# REGULATORY INFORMATION DISTRIBUTION SYSTEM (RIDS)

SUBJECT: Forwards responses to Geosciences Branch Questions 360.14 & 360.17. Faults along Rattlesnake-Wallula alignment are not capable according to NRC criteria. Estimates of potential earthquake magnitudes encl.

December 24, 1981  
G02-81-551  
SS-L-02-CDT-81-113

Subject: NUCLEAR PROJECT NO. 2  
RESPONSES TO REQUESTS FOR INFORMATION

Figure  
360.14-1

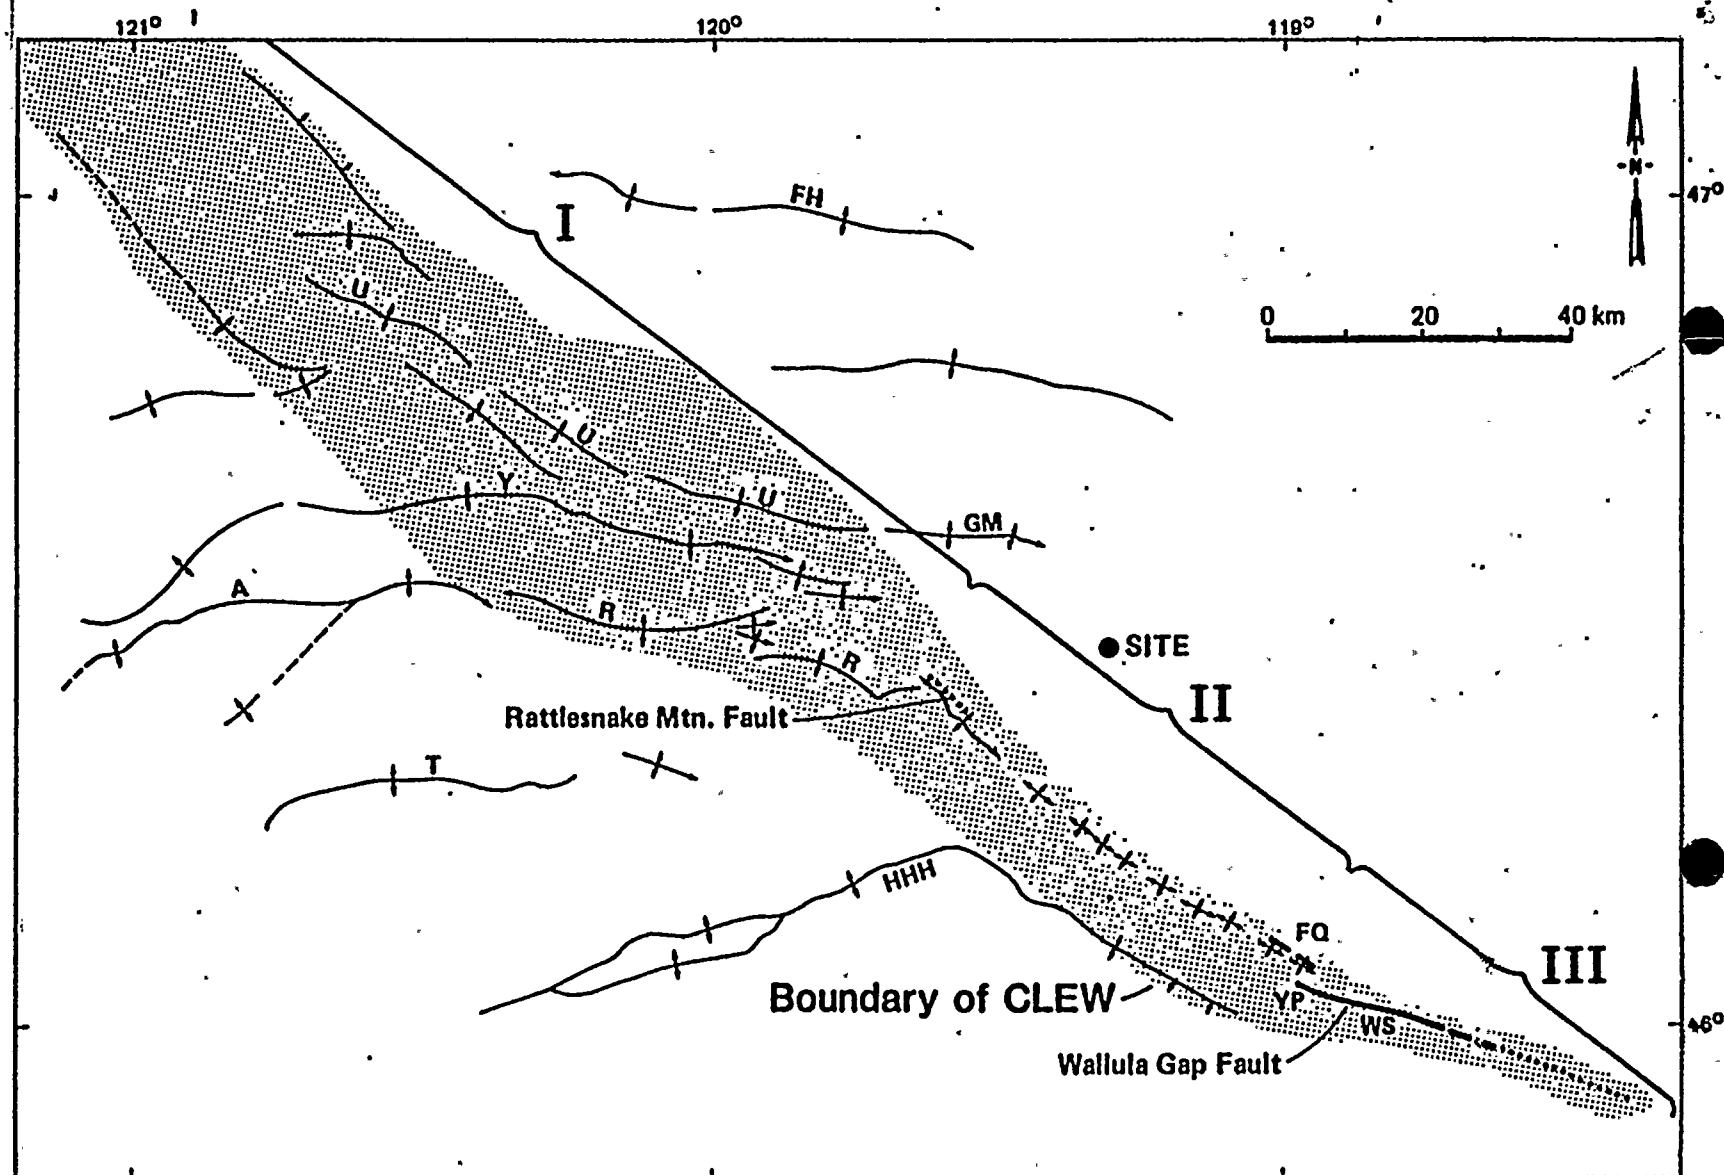
Provide your best deterministic judgement of the length, character, and capability of CLEW within the site region. If you determine it to be segmented as reported in the meeting of November 17-18, 1981, provide a map with topographic base delineating the segments and discuss in detail the character and capability of the individual segments, with supporting basis for all judgements.

The Cle Elum-Wallula lineament (CLEW), as defined by Laubscher (Appendix 2.5-0), is a 240 km-long northwest-trending zone of "en echelon" anticlines that includes part of the Yakima fold belt (Figure 360.014-1). CLEW is coincident with the central third of the Olympic-Wallula lineament (OWL) which was postulated by Raisz (1945). The portion of CLEW that extends from Rattlesnake Mountain southeastward to the vicinity of Milton-Freewater has been termed the Rattlesnake-Wallula alignment (RAW) (Appendix 2.5K).

Davis (Appendix 2.5N) defines three structural domains of CLEW (Figure 360.014-1); domains II and III comprise RAW. Domain I extends south from Cle Elem to Rattlesnake Mountain and is defined by a broad zone of deflected or anomalous fold trends. Although Davis included Rattlesnake Mountain in domain I, the Rattlesnake Mountain anticline is similar in structural style and orientation to the doubly-plunging anticlines of domain II. Therefore, the Rattlesnake Mountain anticline has been included in domain II in this analysis.
